**MONTGOMERY COUNTY HISTORIC PRESERVATION COMMISSION**  
**STAFF REPORT**

<b>Address:</b>	11650 Snowden Farm Pkwy., Germantown Formerly 22022 Ridge Rd.	<b>Meeting Date:</b>	9/3/2025
<b>Resource:</b>	Master Plan Site #13/19 <i>Howes Farm</i>	<b>Report Date:</b>	8/27/2025
<b>Applicant:</b>	NECC	<b>Public Notice:</b>	8/20/2025
<b>Review:</b>	HAWP	<b>Tax Credit:</b>	n/a
<b>Permit Number:</b>	1109684	<b>Staff:</b>	Dan Bruechert
<b>Proposal:</b>	Demolition and reconstruction of barn/accessory building

# Responses to HPC Comments/Recommendations during the consultation meeting held July 9, 2025

DRAWING TITLE  
ELEVATIONS

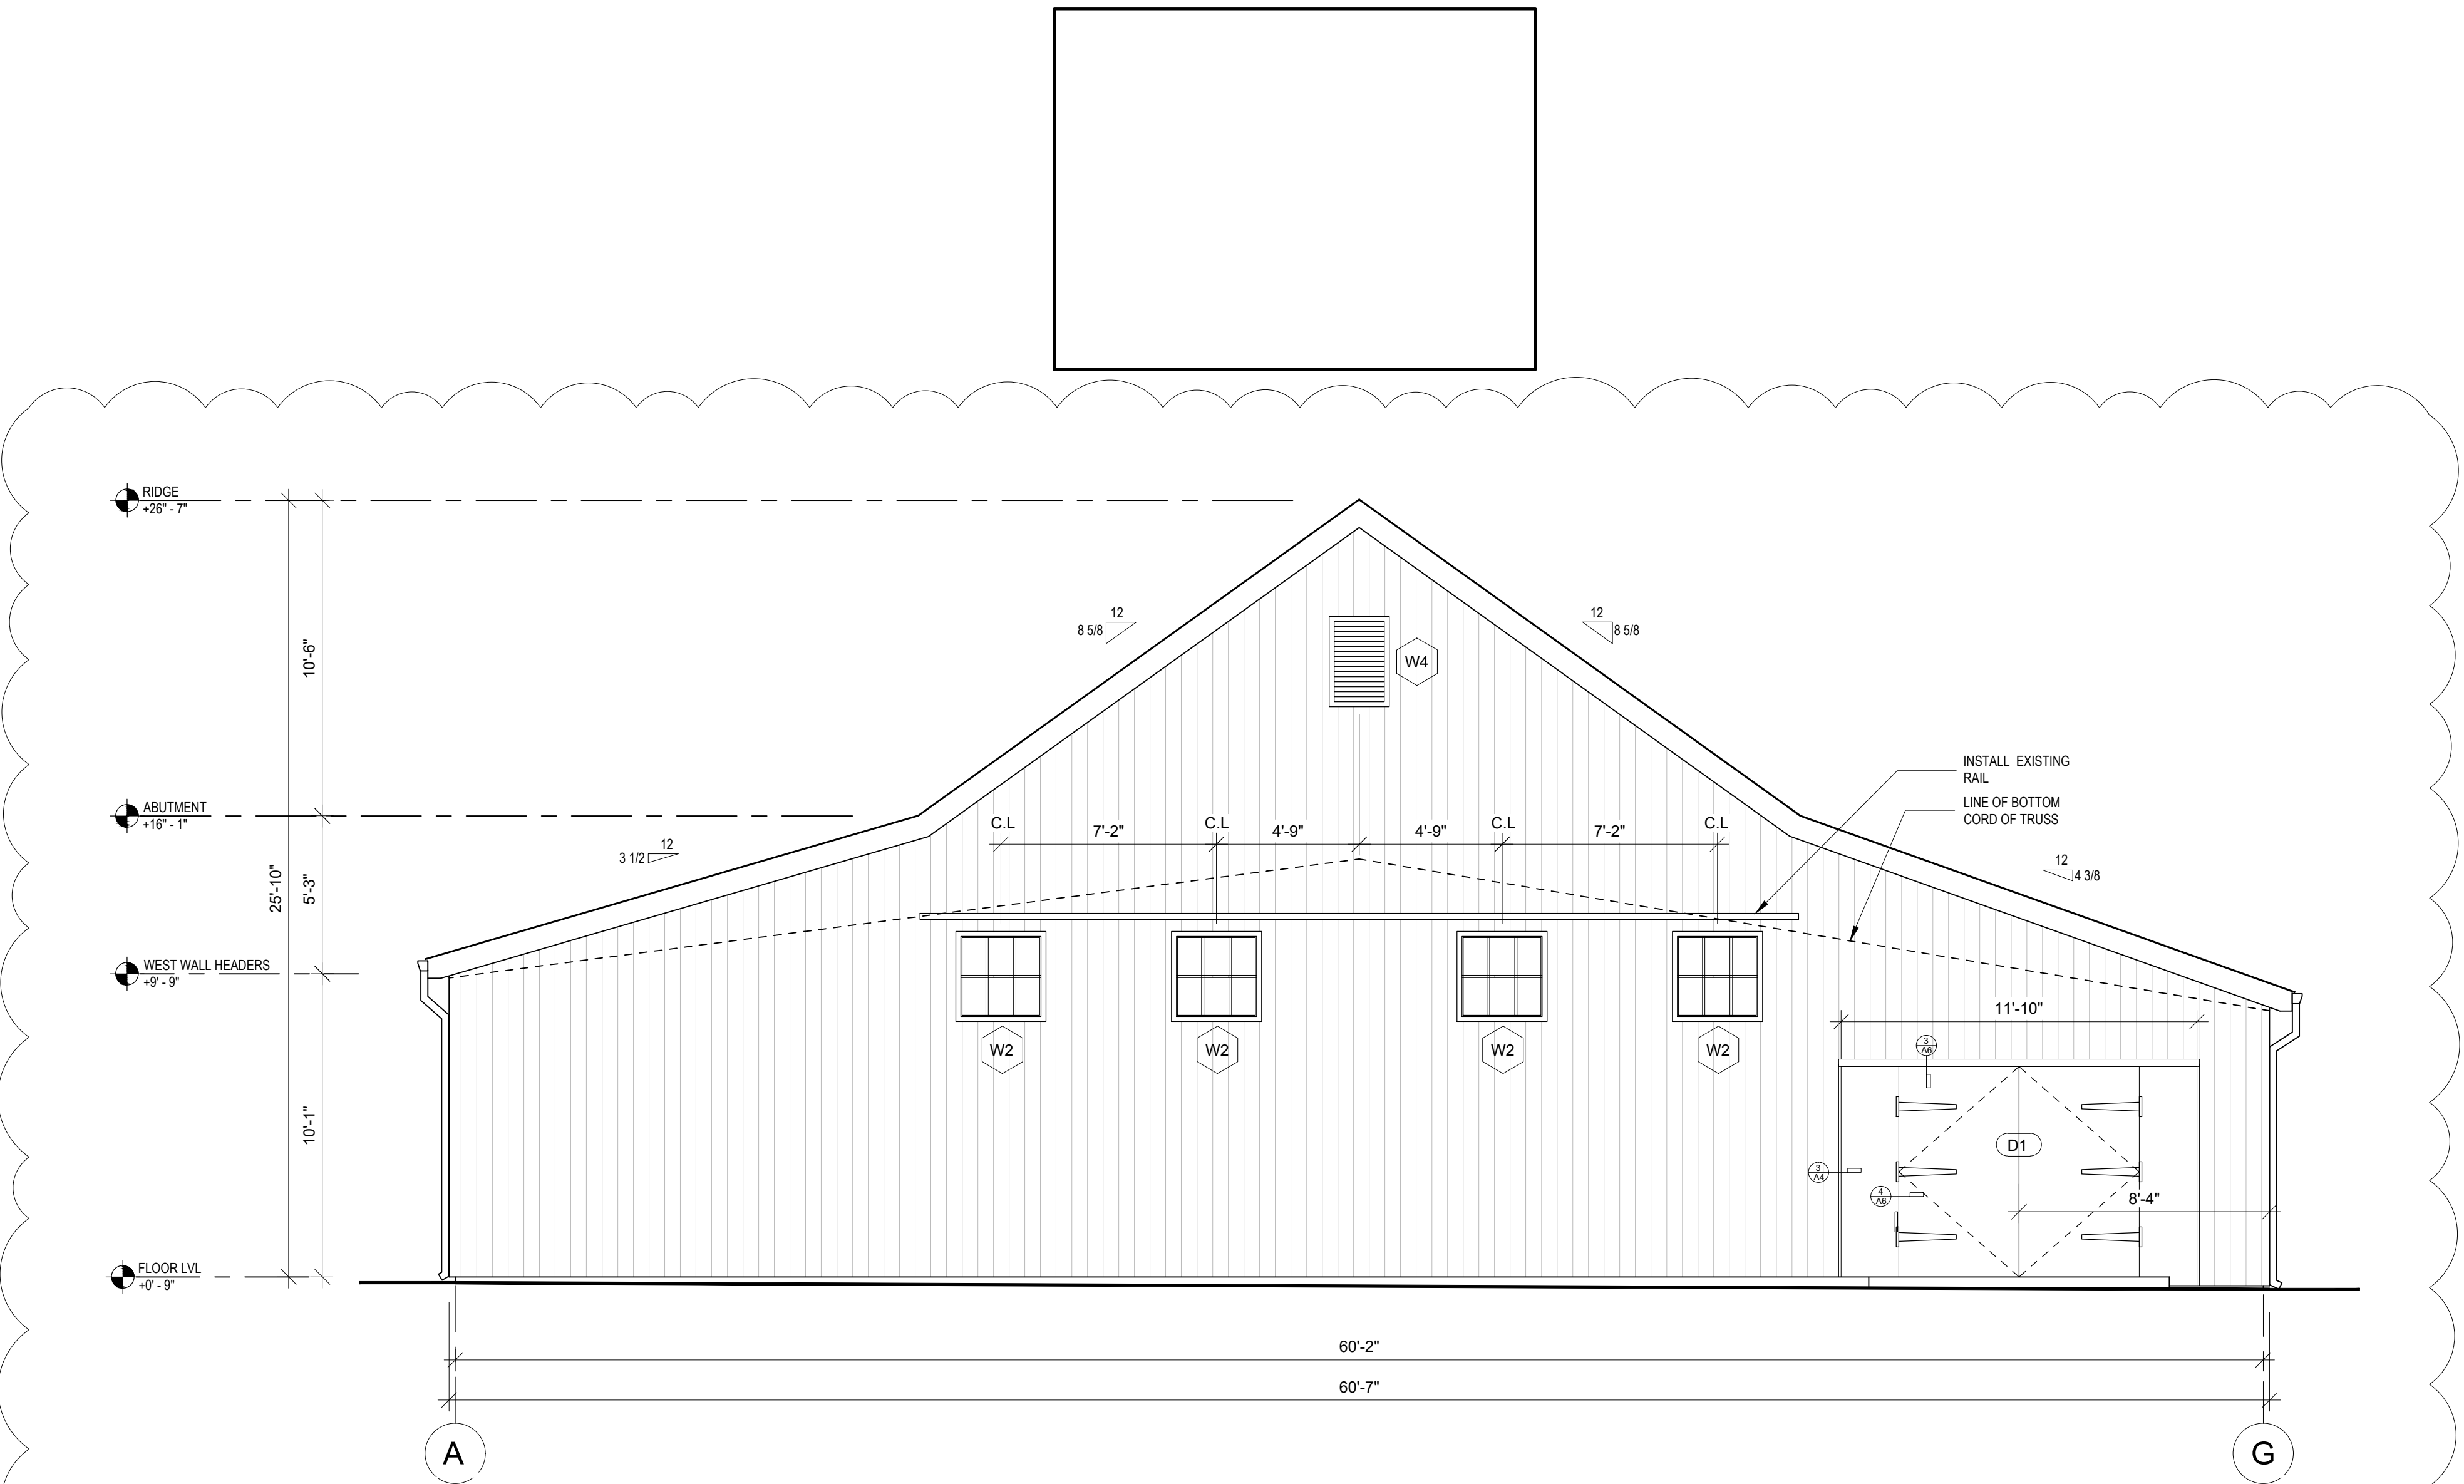
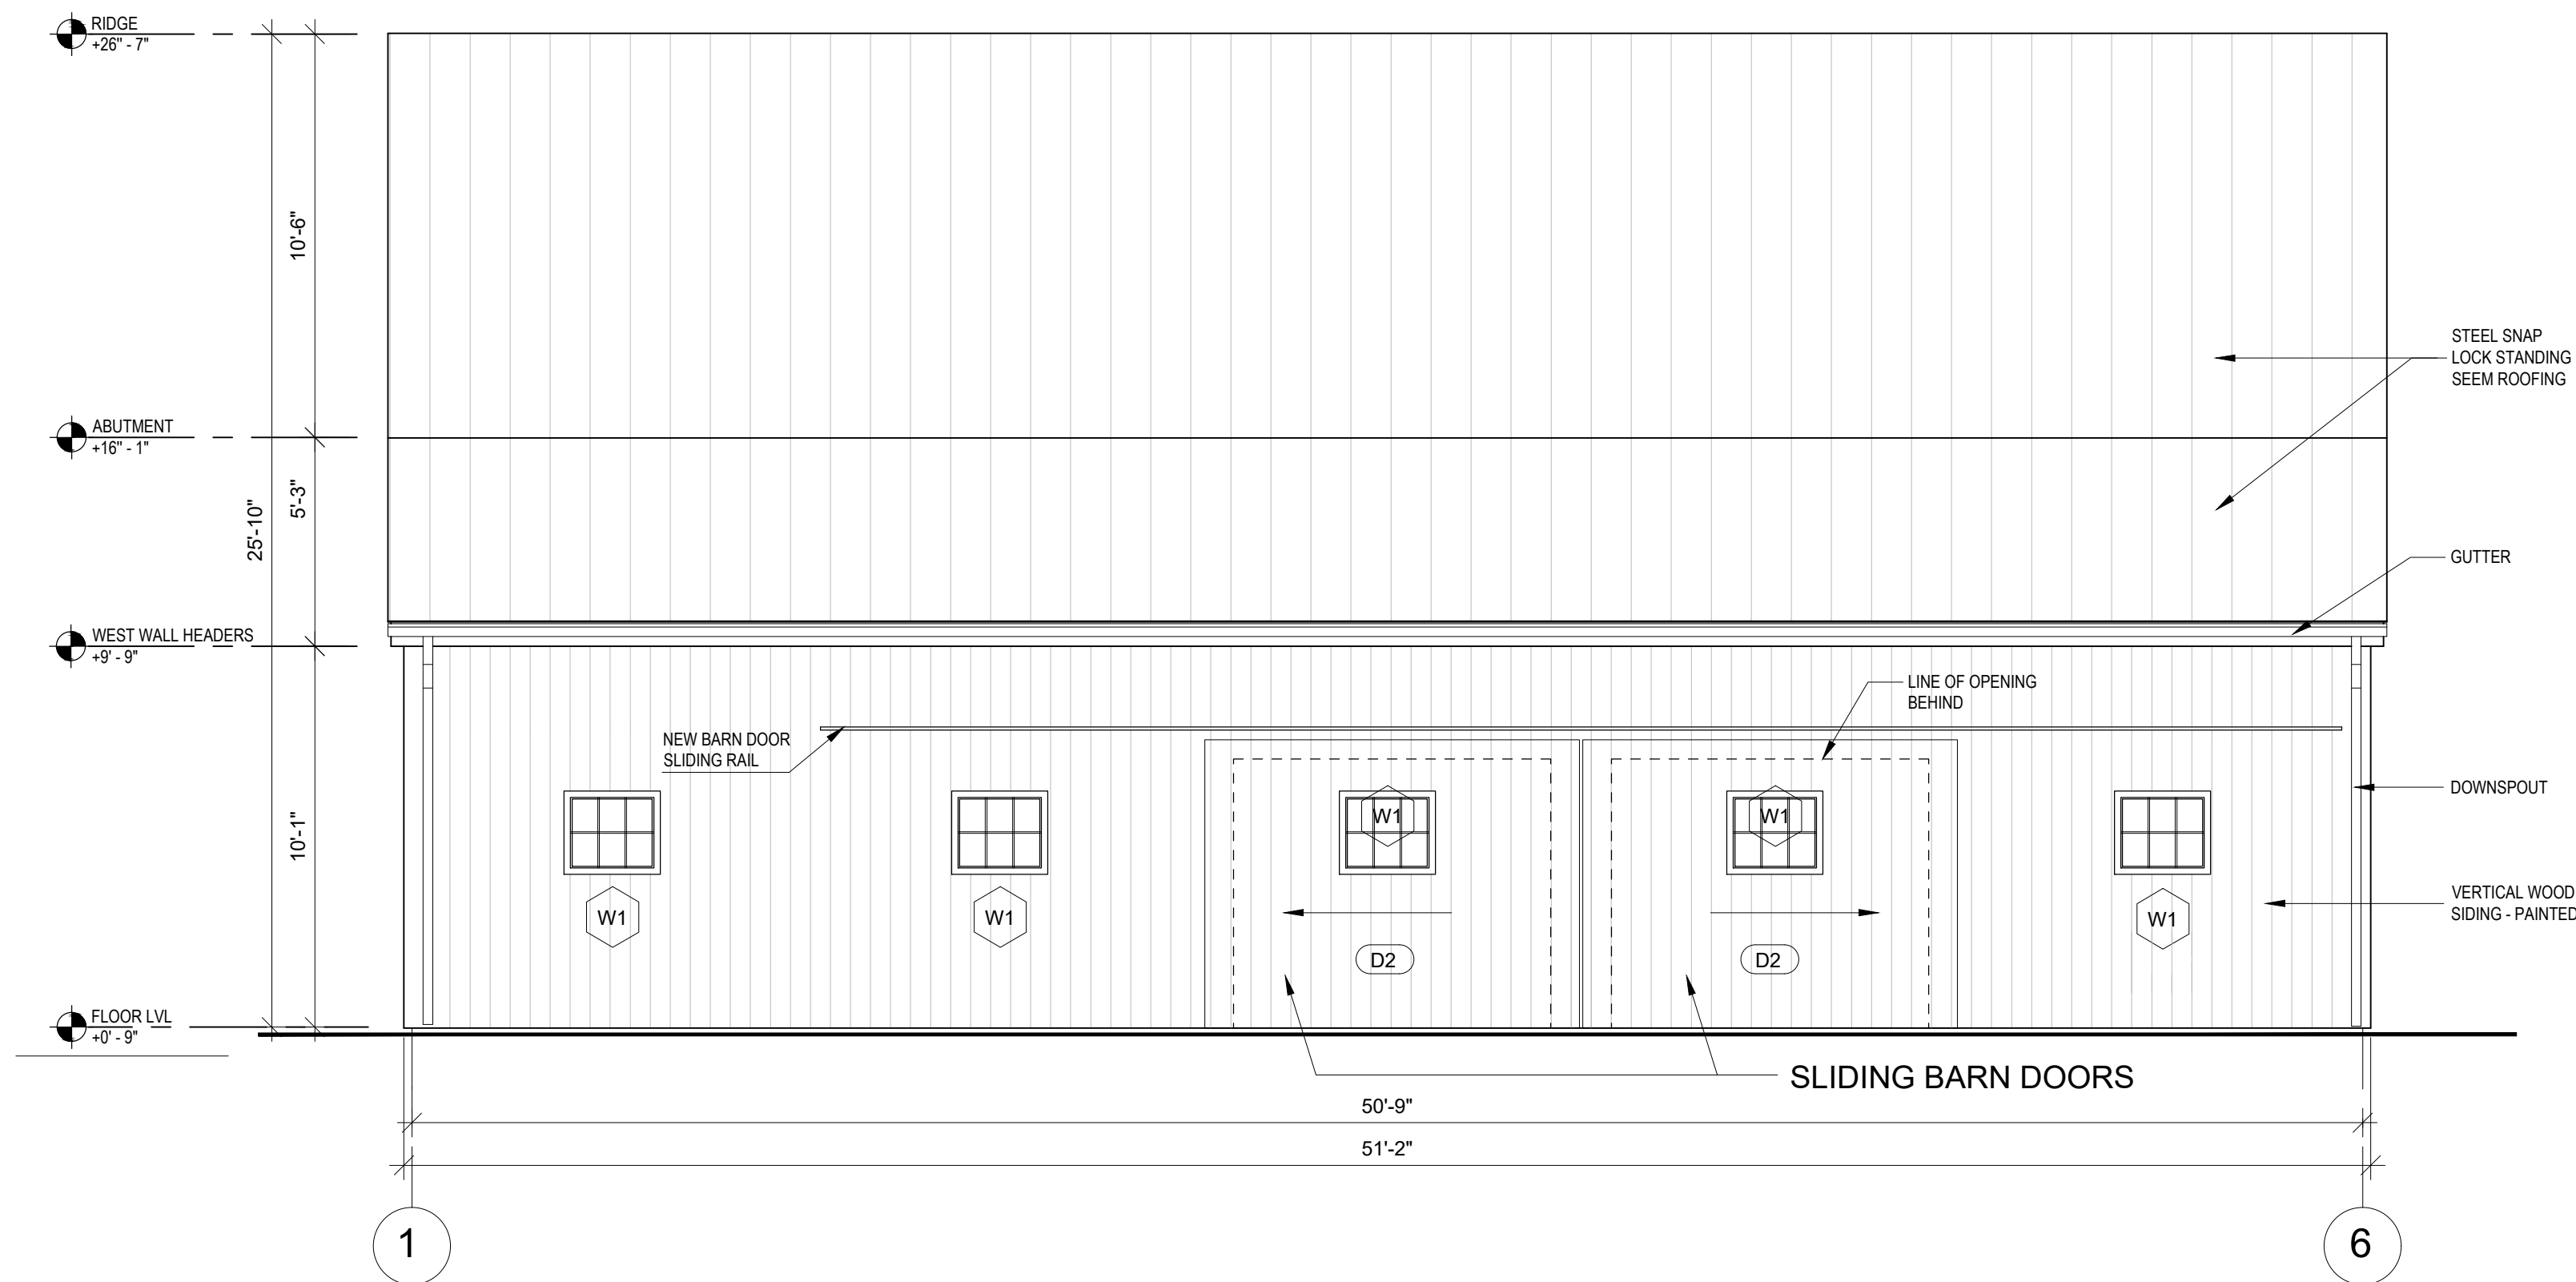
## HPC Comment 2: Roof Slope

## HPC Comment 3: Windows and Doors

NECC: We have made revisions to the drawings to match the existing roof slope. Please refer to drawing sheets A2 for demolition drawing, and A4 and A5 for new elevations and cross sections.

- Doors /windows details are provided with this submittal, refer the sheets A4, A5, and A6 for details.

- As per HPC recommendations, roof slopes have been revised to match the existing roof slopes. Refer the sheets A4, A5, and A6 for details.
- Description of proposed roofing materials can be found here: <https://www.abmartin.net/metal-roofing-panels/abseam>.
